Access Compliance Report

Public Rights-of-Way

(Curb Ramps)

Intersection ID: 28193	Main Street: MARVIN_RD	Cross Street: JOHNSTON_RD	Location: SE
ADA ID: F74EBA4830EA	Ramp Type: BlendTrans2	Initial Pass/Fail: Fail	Overall Compliance: No
Severity Score: 33.75			
Codes/Mitigation Info/Possible Solution		Field Measurements/Component Compliance

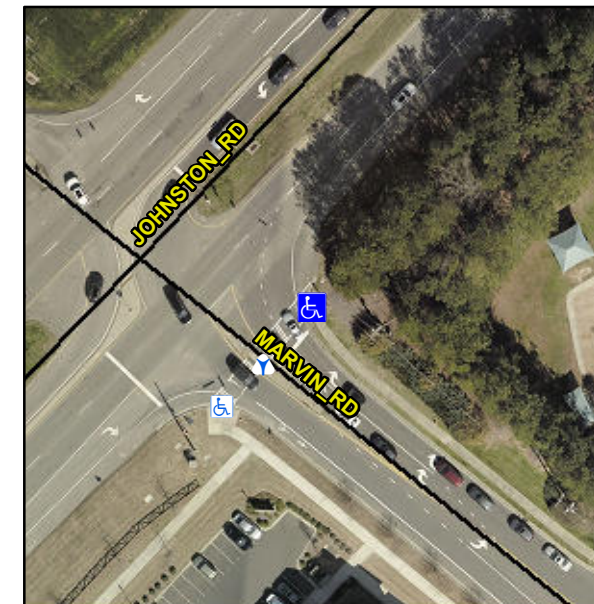
Not Found, R304.5.1, R304.5.3

Compliance	Description	Data	Compliance	Description	Data
N/A	Ramp Length (in)	96.0	Yes	BlendTrans Slope (%)	3.6
No	Ramp Width (in)	47.0	No	BlendTrans XSlope (%)	9.0
N/A	Flare Type LT	N/A	N/A	Flare Type RT	N/A
N/A	Flare Slope LT (%)	N/A	N/A	Flare Slope RT (%)	N/A
N/A	Flare Traversable LT?	N/A	N/A	Flare Traversable RT?	N/A
N/A	Landing Length (in)	N/A	N/A	DWS Provided?	N/A
N/A	Landing Width (in)	N/A	N/A	DWS Contrast?	N/A
N/A	Landing Slope (%)	N/A	N/A	DWS Length (in)	N/A
N/A	Landing X Slope (%)	N/A	N/A	DWS Full Width?	N/A
N/A	Landing Curb? (Y/N)	N/A	N/A	DWS Offset (in)	N/A
N/A	Shared Landing?	N/A			
N/A	Gutter Ponding?	N/A	N/A	Gutter Slope (%)	N/A
N/A	Gutter Lip Ht (in)	N/A	N/A	Gutter X Slope (%)	N/A
N/A	Painted X Walk1?	Yes	N/A	Painted X Walk2?	N/A
	X Walk 1 Direction	To SW		X Walk 2 Direction	N/A
	X Walk 1 Width (in)	108.0		X Walk 2 Width (in)	N/A
	X Walk 1 Slope (%)	1.5		X Walk 2 Slope (%)	N/A
	X Walk 1 X Slope (%)	2.0		X Walk 2 X Slope (%)	N/A

N/A	Ramp inside XWalk1?	Yes	N/A	Ramp inside XWalk2?	N/A
	Road Slope (%)	2.0		Clear Space?	N/A
	Road X Slope (%)	1.5	N/A	Clear Space to XWalk (in)	N/A
N/A	Any Obstructions?	N/A	N/A	Storm Grate/Utility Hazard?	N/A
	Obstruction Type			Storm Grate/Utility Type	
		N/A			N/A
			Yes	Surface Condition? (G/P)	Good
			No	Curb Slope (%)	17.1

Remove & Replace Curb Ramp With Two New Directional Ramps or Equivalent.
